Staff Report

To: Salt Lake City Planning Commission
From: Eric Daems, AICP, Senior Planner, eric.daems@slcgov.com or 801-535-7236
Date: February 26, 2020
Re: Accessory Dwelling Unit – Conditional Use (PLNPCM2019-00992)

PROPERTY ADDRESS: 1039 W Briarcliff Ave
PARCEL ID: 08-35-130-009-0000
MASTER PLAN: Northwest
ZONING DISTRICT: R-1/7,000 (Single Family Residential)

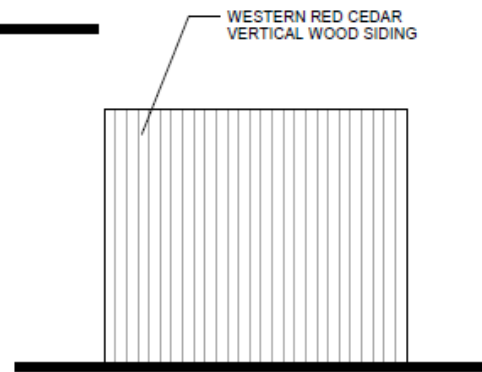
1. The unit is being placed in the back yard in a location that has limited surveillance from the existing structures.
2. In looking at elevation D and C there are no windows, that allow the occupants inside to monitor those areas of the property. These sides are also facing away from the other surrounding buildings, creating spaces that cannot be monitored by anyone. These can be hiding spots or ambush points in the event that a crime is committed here.
3. I was not able to see any exterior lighting on the plans or exterior lighting discussed in the project description.
4. With the placement of the structure on the property, the lack of windows and the ability to see into certain areas of the yard, and lack exterior lighting increase create zones that will make certain crimes easier to commit.
